City of Portland, Maine – Building or Use Permit Application 389 Congress Street, 04101, Tel: (207) 874-8703, FAX: 874-8716

Proposed Project Description:(Please be as specific as possible)
Repair 8'x10' sunporch on Rear of home (replacing windows)

BUILDING PERMIT REPORT

REASON FOR PERMIT: Rebuild sun porch

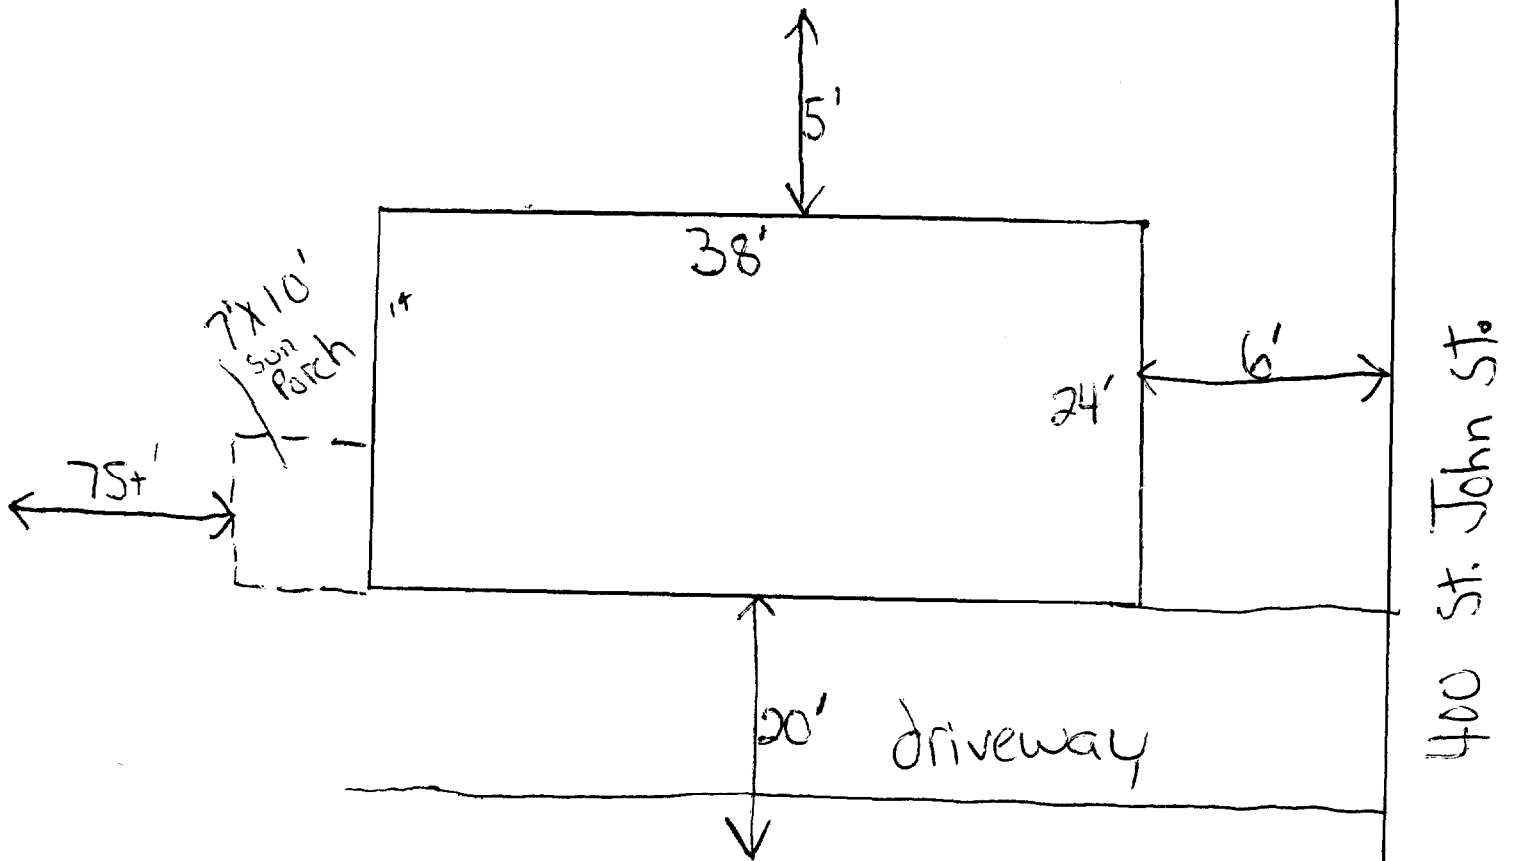
RePlacing windows on SunPorch

R-6 Zone

Rear: 20' req. - 75' shown

Sides: 10' req. - 20' & 19' shown
